Product Change Notification

1. ECR #: 199084 Notification #: 550 2. Date of Announcement: December 22, 2020

- T1PD 1MM T1XD CABLE ASSEMBLY
- T1PDT 1MM T1XD CABLE ASSEMBLY
- T1SD 1MM T1XD CABLE ASSEMBLY
- T1SDT 1MM T1XD CABLE ASSEMBLY

4. Part #'s Affected

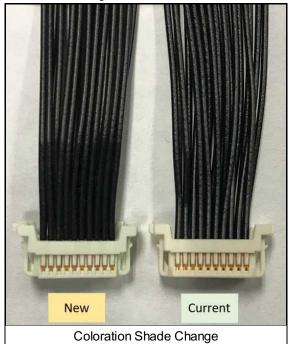
Insulator material change from "NYLON UL94V-2" to "NYLON UL94V-0", and along with color shade changes; This will be a rolling change and new revision insulator will be used once current revision is depleted.

There will be a slight color shade difference between new and current material.

Upgrading the UL flammability rating of insulator from UL94V-2 to UL94V-0.

- Function Upgrading the UL flammability rating of insulator from UL94V-2 to UL94V-0.
- Form Slight color shade difference between new and current material.
